LOT 2 – CROSSROADS MIXED USE FILING NO. 2

INTERIM GRADING & EROSION CONTROL PLAN

GEC02

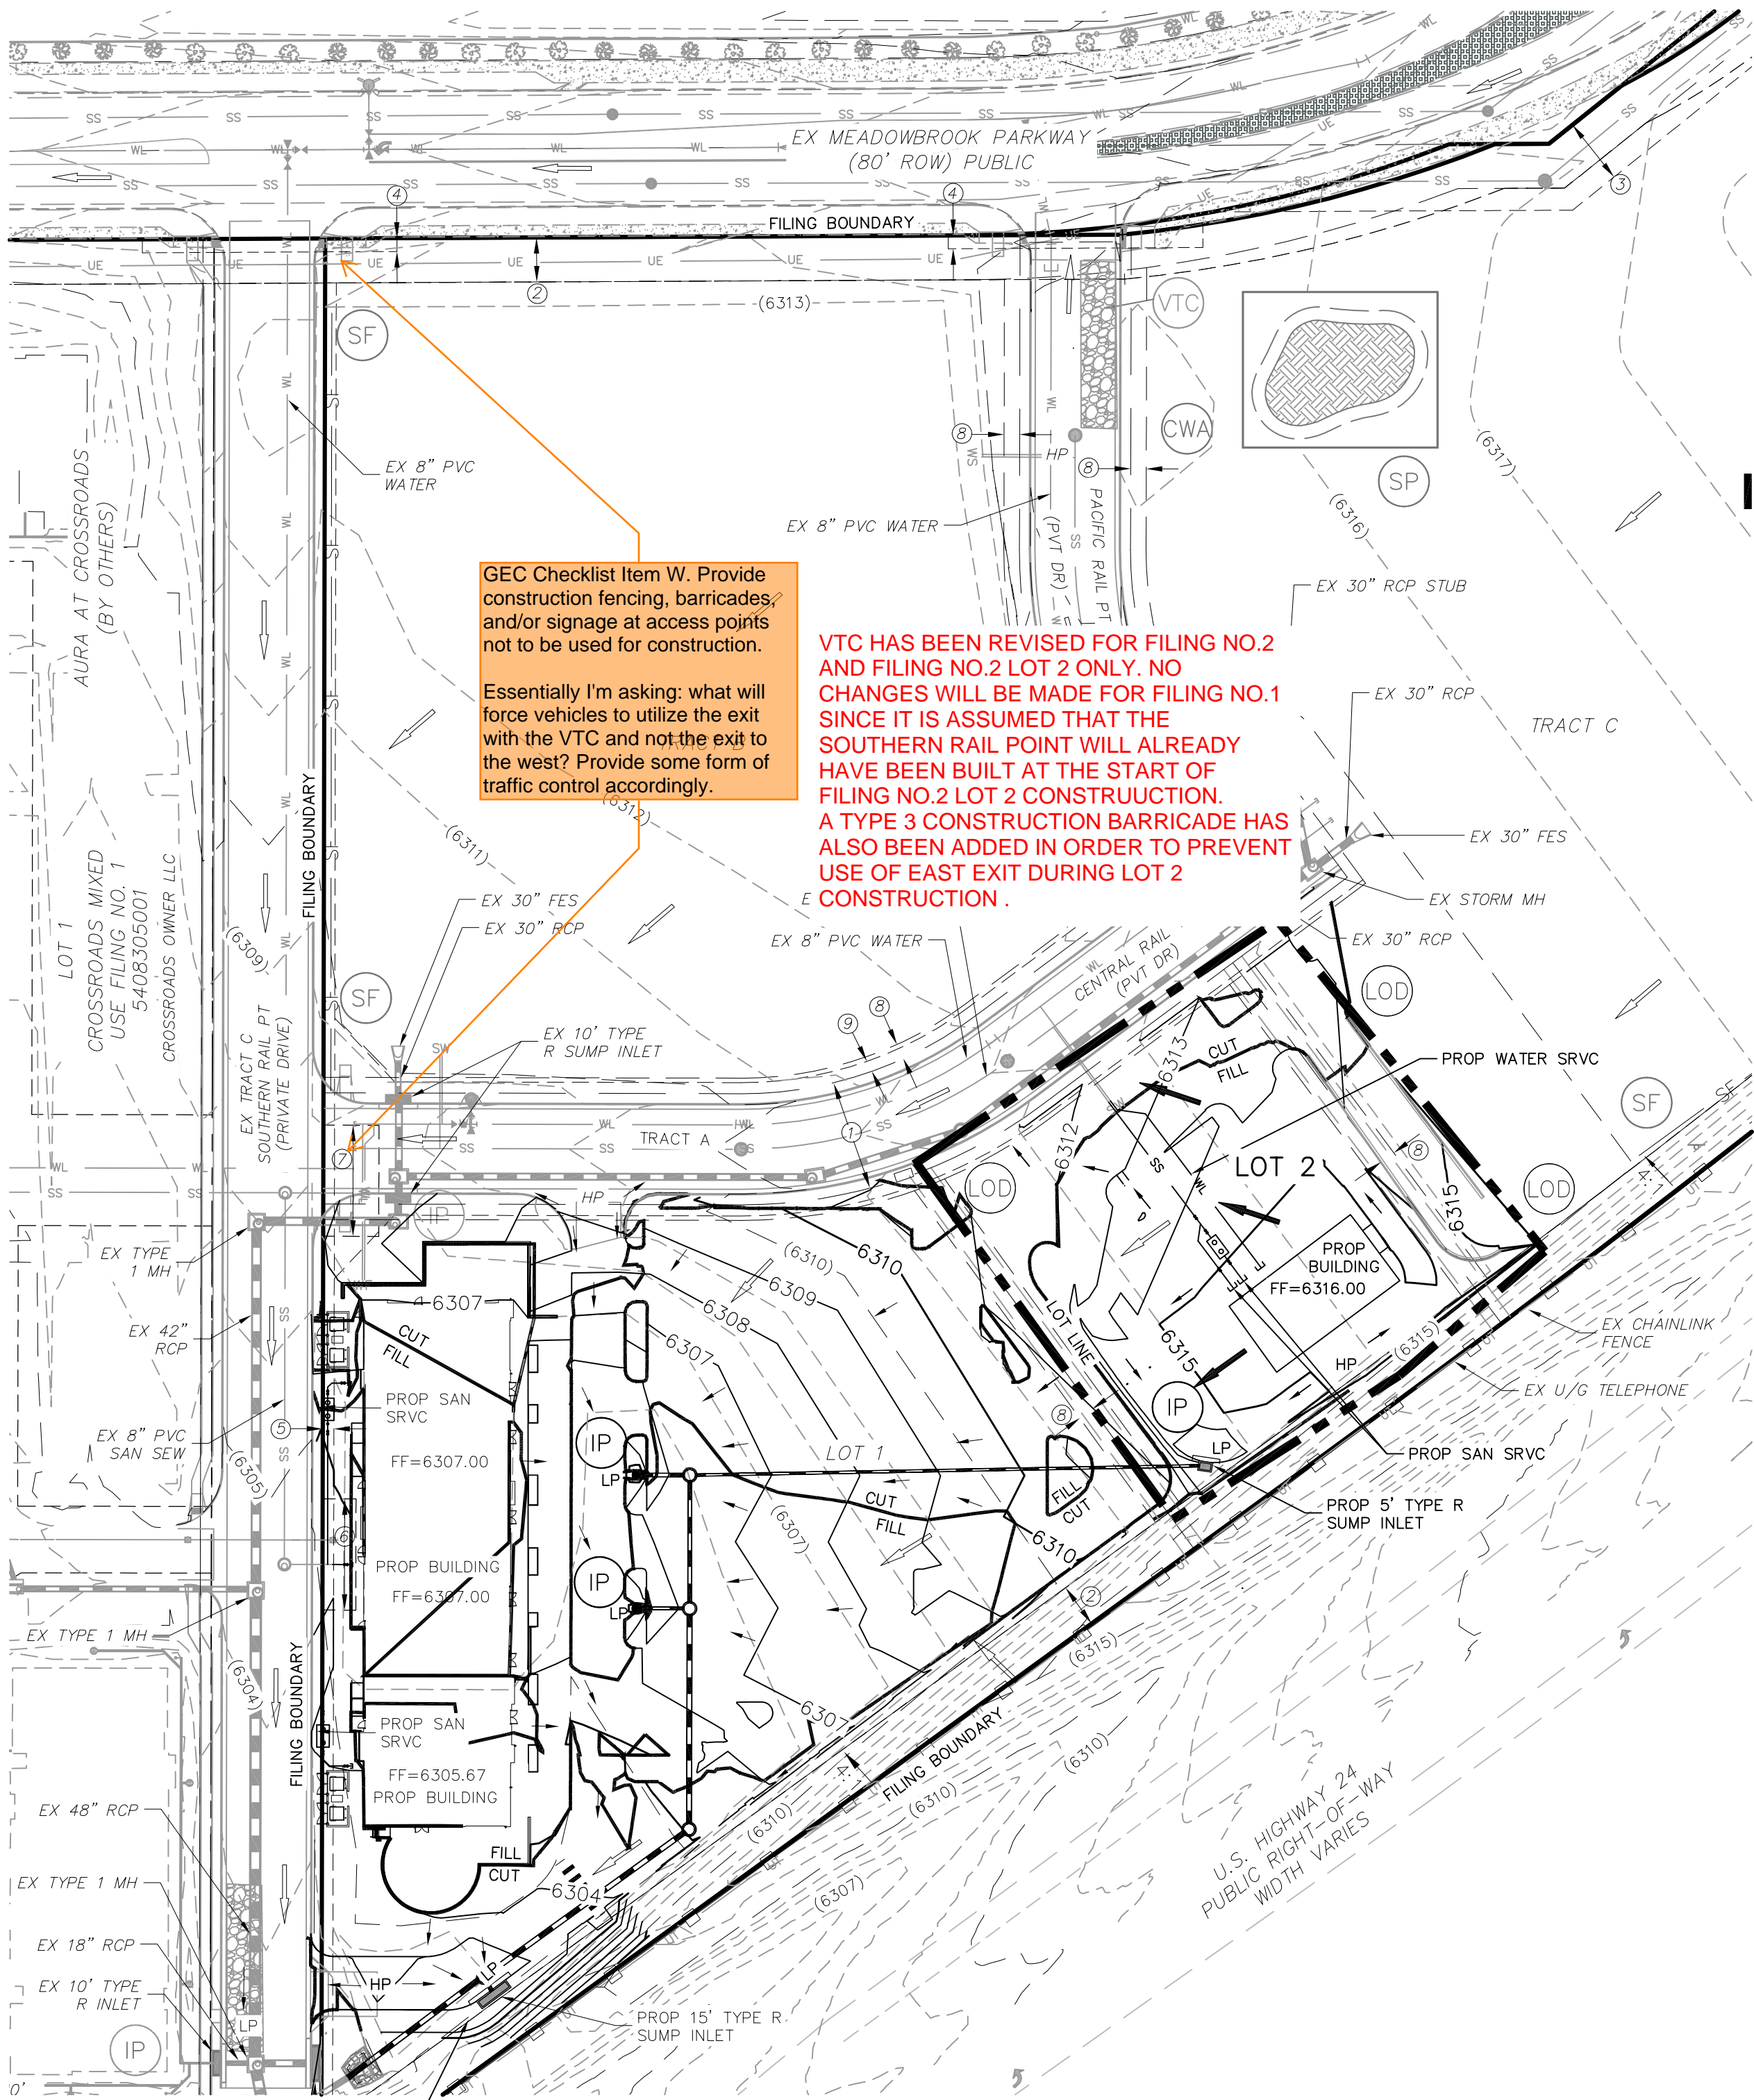
GEC Checklist Item W. Provide construction fencing, barricades, and/or signage at access points not to be used for construction.

Essentially I'm asking: what will force vehicles to utilize the exit with the VTC and not the exit to the west? Provide some form of traffic control accordingly.

VTC HAS BEEN REVISED FOR FILING NO.2 AND FILING NO.2 LOT 2 ONLY. NO CHANGES WILL BE MADE FOR FILING NO.1 SINCE IT IS ASSUMED THAT THE SOUTHERN RAIL POINT WILL ALREADY HAVE BEEN BUILT AT THE START OF FILING NO.2 LOT 2 CONSTRUCTION. A TYPE 3 CONSTRUCTION BARRICADE HAS ALSO BEEN ADDED IN ORDER TO PREVENT USE OF EAST EXIT DURING LOT 2 CONSTRUCTION.

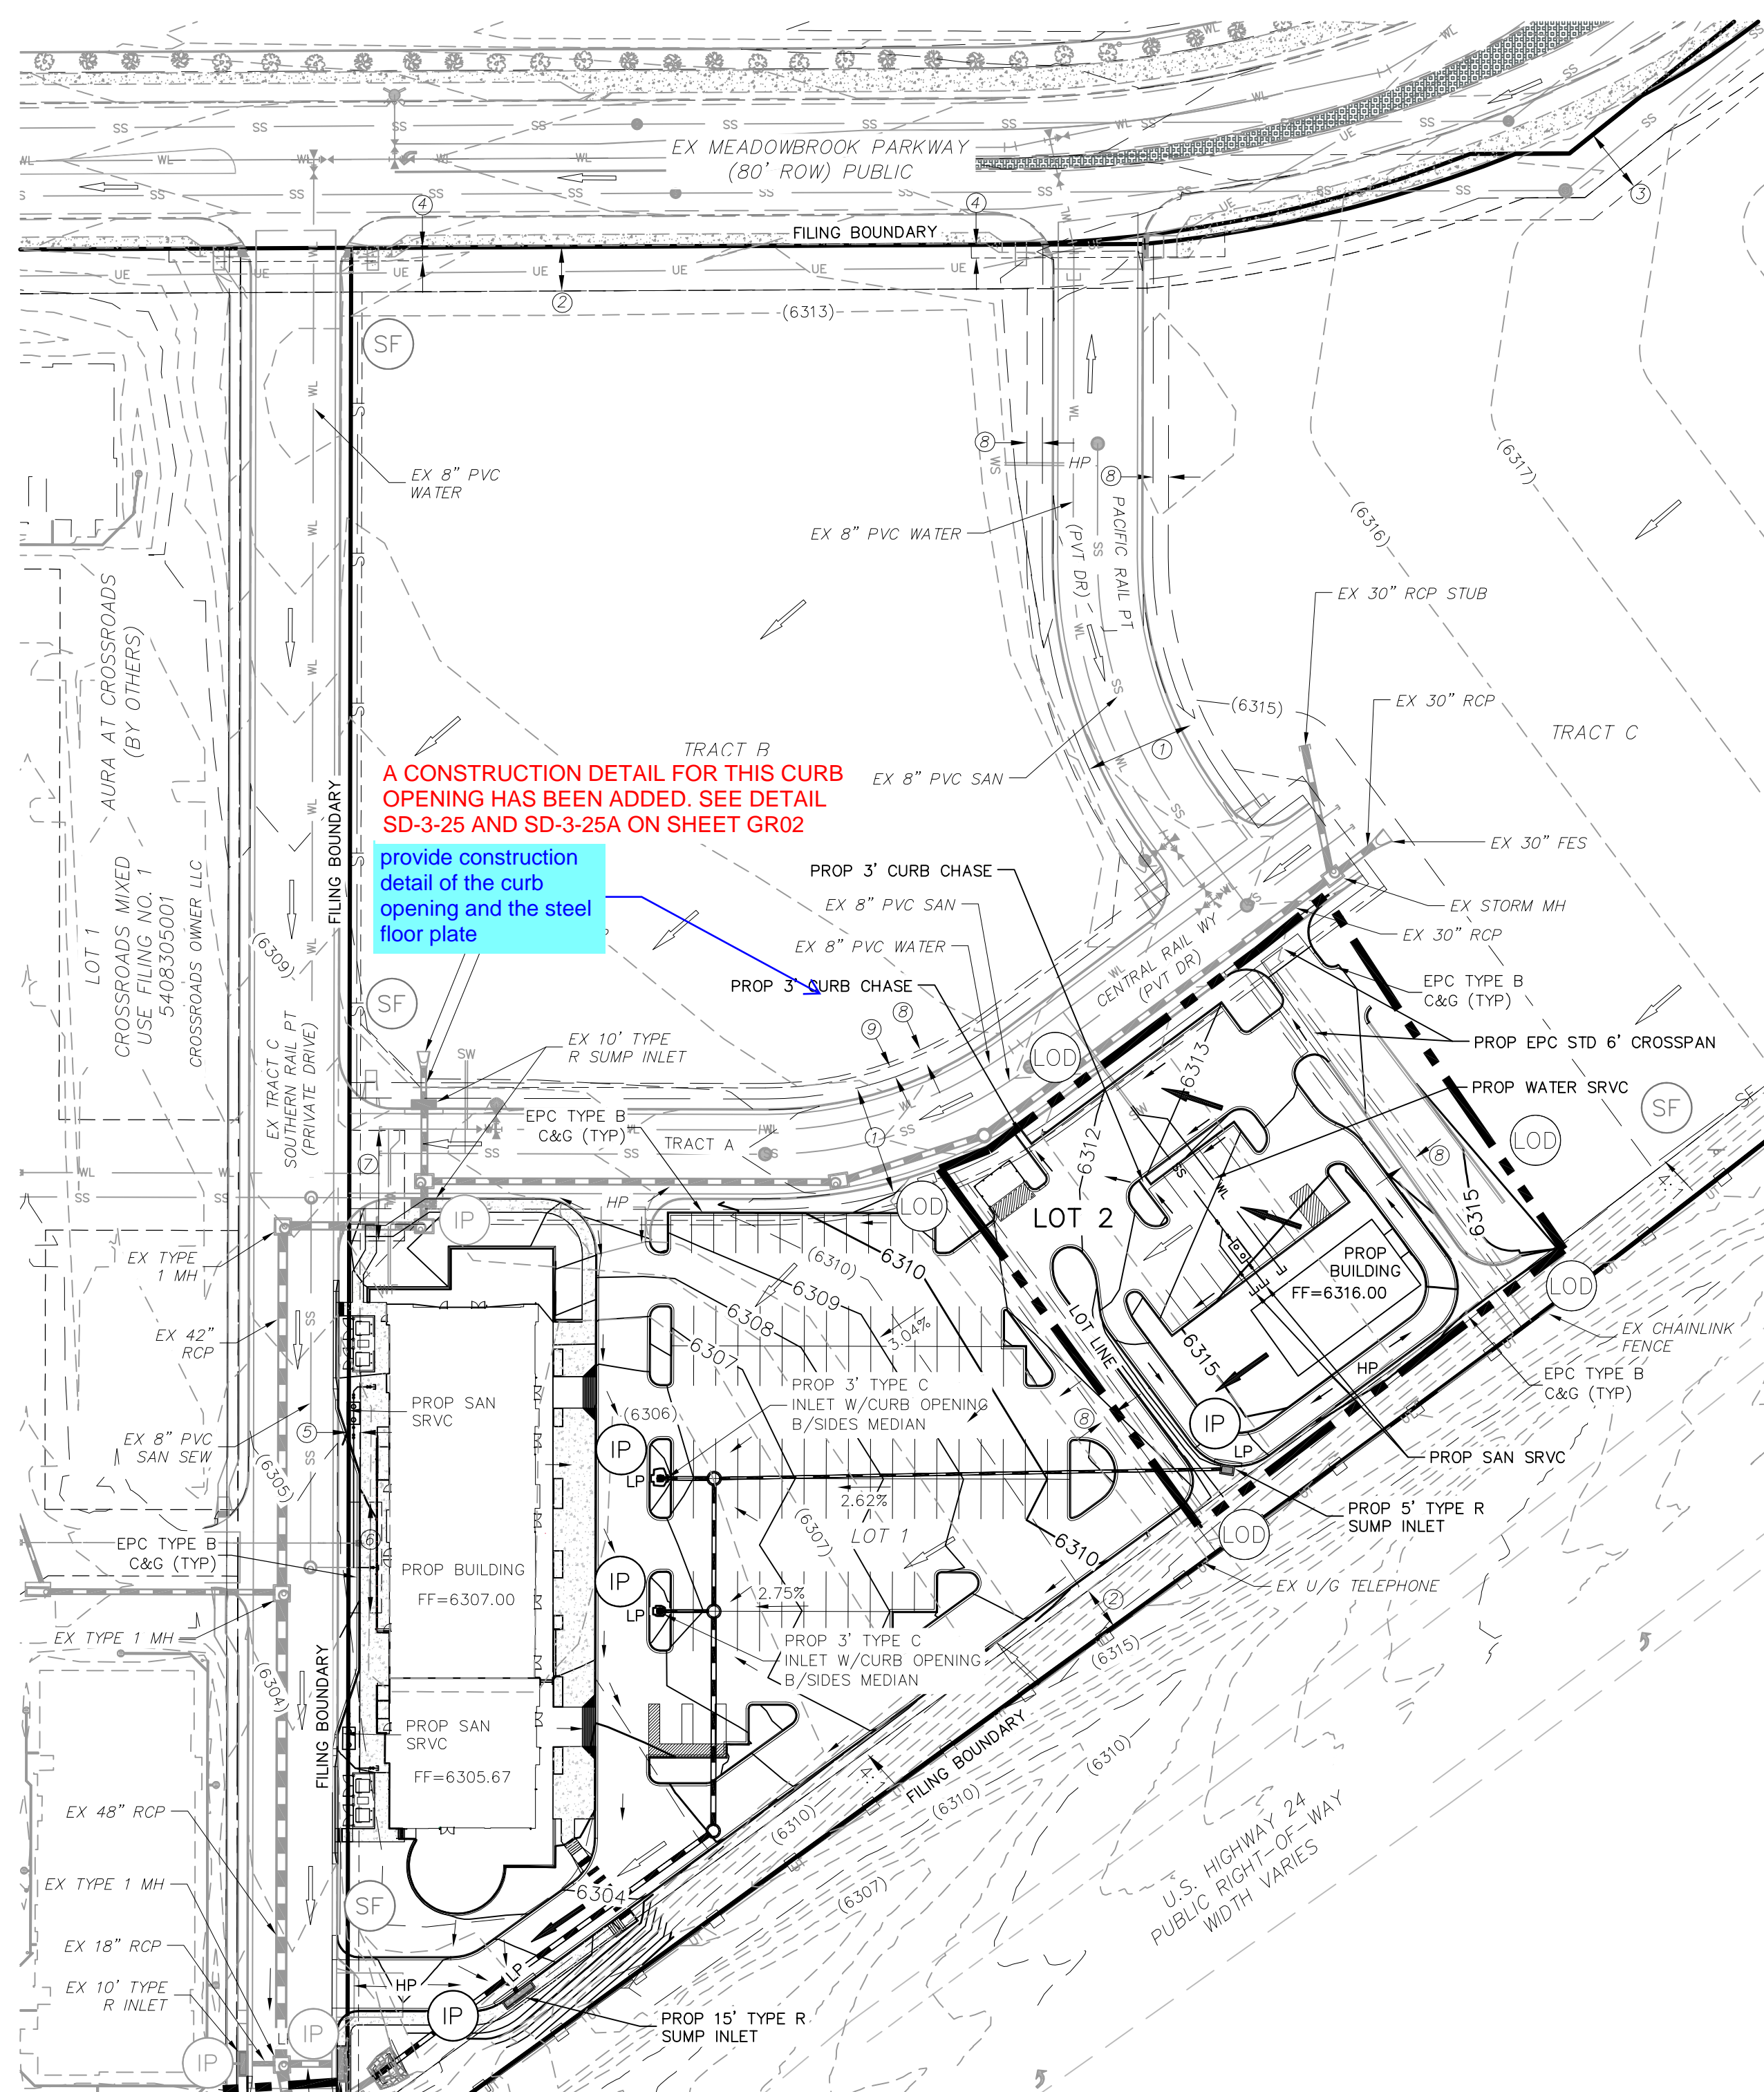
provide construction detail of the curb opening and the steel floor plate

A CONSTRUCTION DETAIL FOR THIS CURB
OPENING HAS BEEN ADDED. SEE DETAIL
SD-3-25 AND SD-3-25A ON SHEET GR02

GEC04

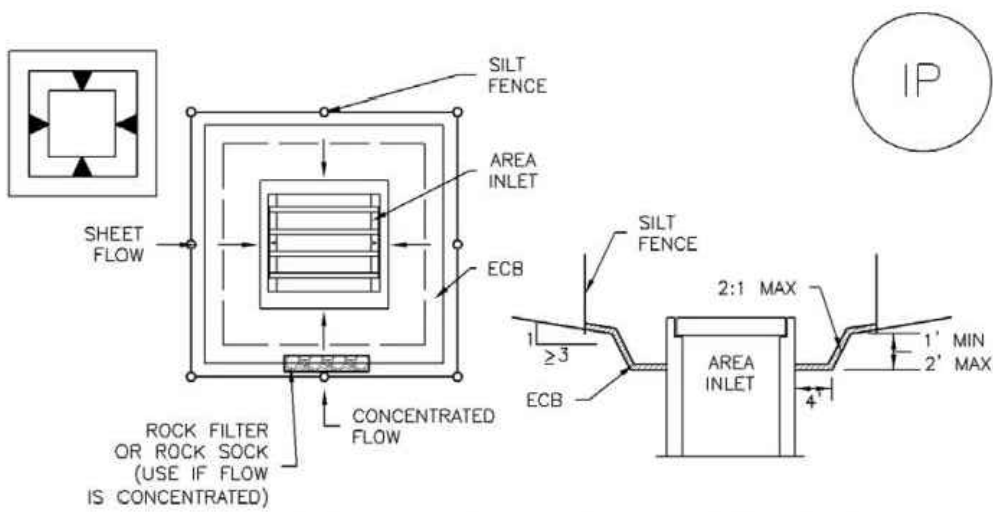
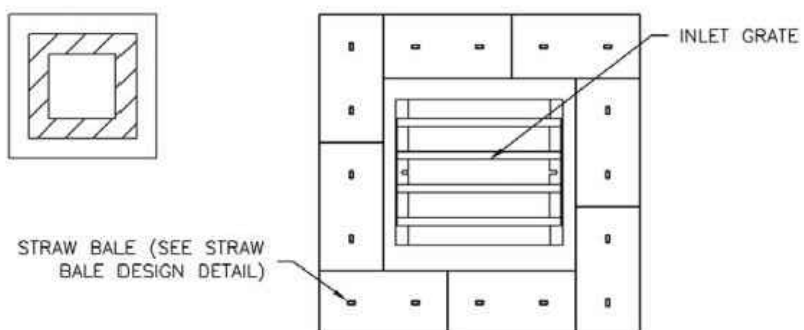
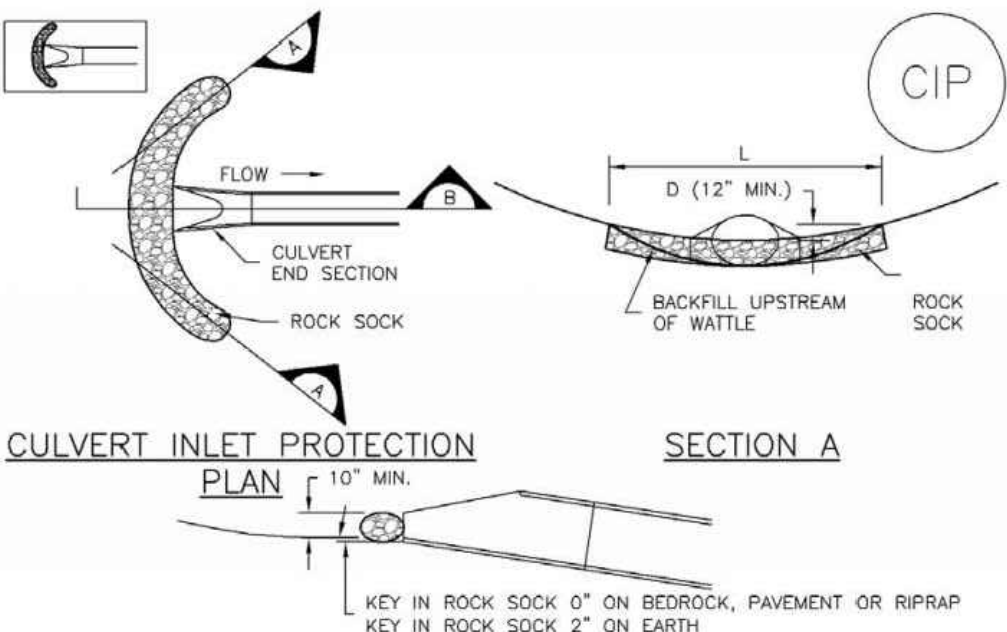
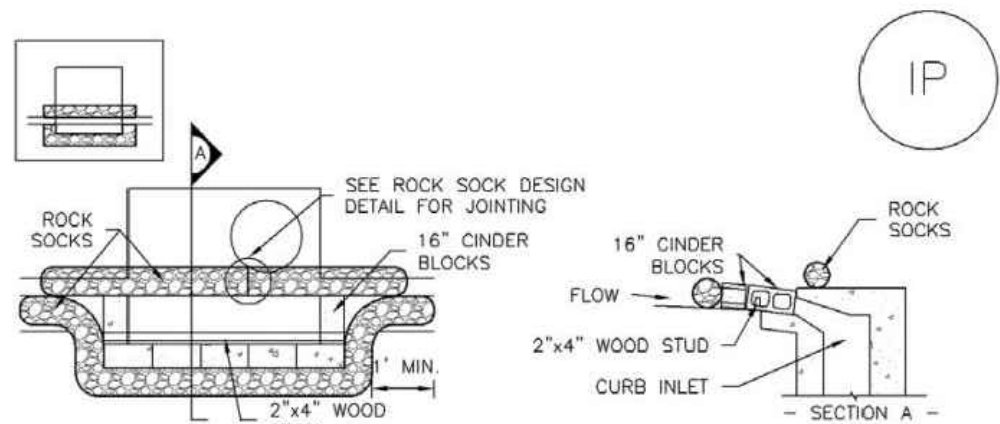
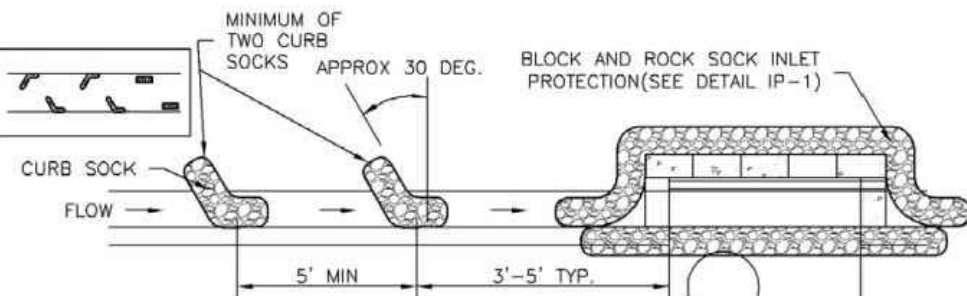
GEC Checklist Item Z. Include details for the following BMP's. Examples of acceptable details for each are provided. Even though these are all existing BMPs for this site, it would be good to have details on this plan set so everyone is aware of the install and maintenance requirements for all lots that are utilizing those existing (previously installed) BMPs.

ALL OF THE REQUESTED BMPs HAVE BEEN ADDED EVENTHOUGH THEY WILL BE EXISTING FROM THE FILING NO. 2 CONSTRUCTION
